# **Expert Rebuttal Report of David Sabatini, PhD, PE, BCEE**

**January 14, 2025**

My methodology for assessing Dr. Hennet's Expert Report Opinions 2, 10 and 13 was to evaluate the basis of his opinions relative to losses of VOCs during water treatment, storage, and filling of water buffaloes, study the supporting documents that Hennet relies upon along with the AH Environmental Report (2004), perform calculations to help identify reasons for the disparity in estimated losses between the two studies, evaluate appropriateness of input parameters to Hennet's calculations, and assess limitations of the approaches utilized to estimate VOC losses. Based on these analyses and my professional experience and judgment, I suggest modifications to Hennet's calculations that, in my opinion, more accurately capture the losses experienced in water treatment and storage at Camp Lejeune.

Figure 5.1 Flow Schematic for Water Treatment and Distribution (Hennet, 2024, p. 5-2)

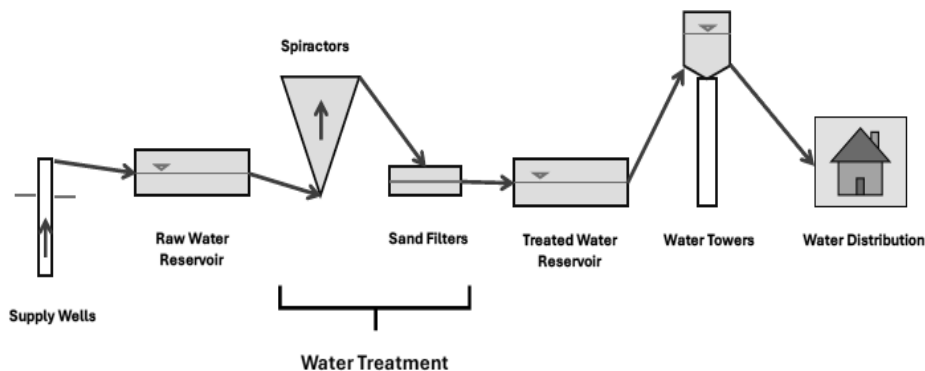
The main points of potential VOC losses estimated by Hennet (2024) and AH Environmental (2004) are in the treatment process (specifically the Spiractors), the raw water storage (Hadnot Point only), and the treated storage (clearwell) tanks, and the water towers. Since the Spiractor design volumes and flow rates were the same for all Spiractors in both treatment systems, the VOC loss estimate approach applies to Tarawa Terrace and Hadnot Point as discussed in the next section. Since raw water storage, clearwell, and water tower VOC losses are estimated similarly but vary by tank size and flow rate, they will be discussed in the subsequent section. I will present the VOC loss estimates from Hennet (2024) and AH Environmental (2004) along with my own conclusions based on my calculations and assessments.

Figure 5-2 – Schematic of Water Buffalo showing filler pipe (top figure) and strainer (#22 in lower figure and listed in the table) – Hennet, 2024, p. C-15. Note: Redline dimensions on Hennet’s water buffalo diagram are in error, refer to upper table for dimensions.

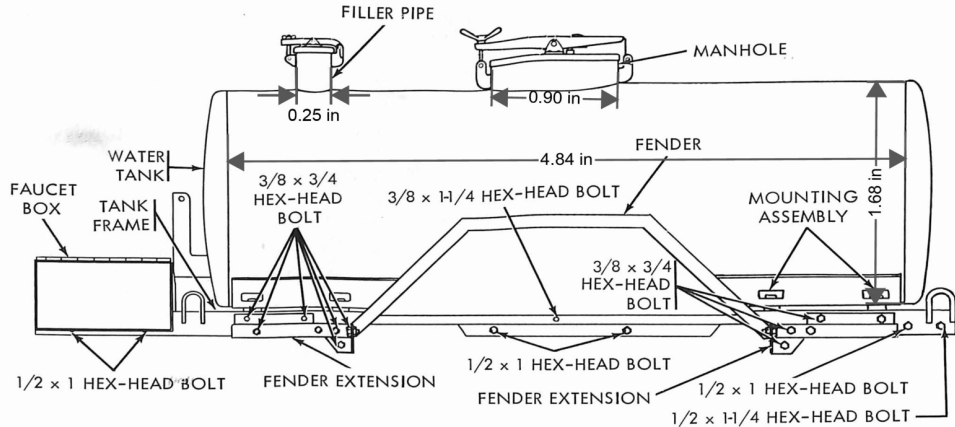
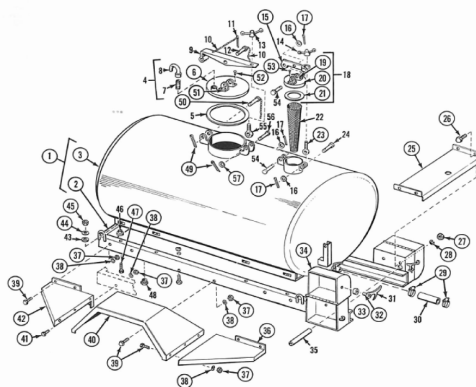
Assuming the tank was filled through the filler pipe and strainer, an assumption addressed further below, there are fundamental differences between the shower and buffalo systems that Hennet does not address, namely time for volatilization and cross sectional area for mass transfer. Relative to time of volatilization, the shower-based VOC loss is for a 1.6 m drop from the showerhead to the bathtub (McKone and Knezovich, 1991, Table 1). As Hennet (2024) points out, the water buffaloes are 0.8 m tall (see upper table in Figure 5-2). During

initial filling, the entire 0.8 m fall would be experienced. As the tank approaches full, the fall height approaches zero (in contrast, during the shower experiment, the fall height remains 1.6 m throughout and the air to water remains the same since the water drains). As such, during filling, the water buffalo would have an average fall height of 0.4 m, which is 1/4th (25%) of that in the shower experiment. Assuming that the shower and strainer produce similar spray patterns with similar downward velocities, and given that the relative time for volatilization is the fall distance divided by downward velocity, since the downward velocities are assumed to be the same, the relative time for volatilization is proportional to the relative fall heights (the velocities cancel out in the ratio). Assuming the strainer produces a similar spray pattern (cross-sectional area) to the shower, no adjustment is necessary for the mass transfer area in this case. Thus, my VOC loss estimate in Table 5-6, Row 3 is  $\frac{1}{4}$  (0.4 m / 1.6 m) or 25% of what Hennet estimates in Row 1 of the same table, which I apply to filling of the tank. If the strainer produced a smaller degree of spray relative to the shower the losses would be reduced, further supporting my lower estimate compared to Hennet's.
